# Hydrologic/Hydraulic Study Highlights

## Conceptual Design & Channel Hydraulics Summary

Manning's Equation for Open Channel Flow

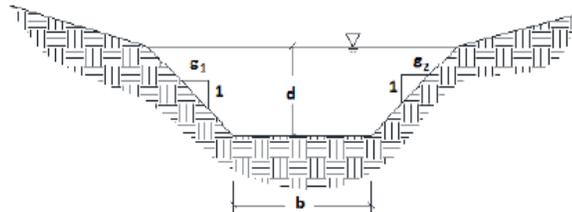
| <p style="text-align: center;"><b>RECOMMENDATIONS FROM THE HYDROLOGICAL STUDY</b></p>   | <p style="text-align: center;"><i>Comments from<br/>Practical Proposal<br/>Authors</i></p>   |
|---|--|
| <p><b>Conceptual Grading Plan and Flood Extents:</b> “Results indicate that it does appear feasible to construct a channel through Ponds 3 and 4 that would avoid flooding of any existing structures (around pond 3 and 4).”</p> <ul style="list-style-type: none"> <li>• While most of the earth moving involved in constructing such a channel would be filling in the existing ponds, the <b>weir between Ponds 3 and 4 will need significant alteration/removal.</b></li> <li>• The new channel flow line would be roughly 3.5 feet lower than the existing level of Pond 3 at the weir. As a result, <b>retaining walls may be required</b> to shore up the decks and patios at 709/713 Moss Creek Circle, and at 600/604 Winslow Farm Drive.</li> <li>• <b>River cobbles</b> having maximum diameter of 4 - 5 inches could be used in the flow line of the channel. <b>Larger material such as boulders or riprap</b> may be appropriate where steps or drops may occur in the channel profile, or at constrictions, culverts, retaining walls, etc.</li> <li>• Other <b>vegetative erosion control measure</b> such as willow fascines and live staking may also be applicable.</li> <li>• <b>Channel banks could be stabilized initially</b> with erosion control blanket (ECB) which will degrade once the vegetation is established. ECB composed of coconut fiber with netting is capable of handling shear stress of up to 2.25 lb/ft<sup>2</sup></li> </ul> | <p><i>The study does conclude that the topography and the necessary width between the units make a stream channel feasible. However, note the comments highlighted in bold as there are significant considerations to ensure that the stream channel functions effectively.</i></p>  |
| <p><b>Recommendations for Further Study</b></p> <ul style="list-style-type: none"> <li>• <b>Additional analysis and hydrologic modeling</b> are recommended to verify the drainage area and peak flow estimated.</li> <li>• It should be noted that an additional <b>topographic survey will be required</b> to advance this design beyond the conceptual stage.</li> <li>• Local <b>utility</b> infrastructure should be evaluated, <b>relocations</b> may be necessary for the construction of the channel.</li> <li>• The <b>karst geology</b> should be investigated and evaluated with respect to the existing impermeable liners and whether they should remain in place or be removed with the construction of a stream channel.</li> <li>• Geomorphic analysis of the existing channel <b>upstream</b> of Winslow Farm Drive will be needed.</li> <li>• The ponds and culverts <b>downstream</b> of Pond 4 should be evaluated with respect to their capacity to carry the 100-year flow and how backwater effects may impact the channel design.</li> <li>• <b>Permitting</b> strategy should be discussed with representatives of the U.S. Army Corps of Engineers (USACE) and Indiana Department of Environmental Management (IDEM)</li> </ul>   | <p><i>Take note of the recommendations for the need for further studies to convert pond 3 and 4 to stream channel. Each study has the potential of costing thousands of dollars. The report makes it clear that this is a preliminary report and additional investigation is required. Of particular interest is the comments that the utilities may need to be relocated, and an analysis is needed to ensure flooding upstream (Olde Mill area) will not occur with this design.</i></p> |
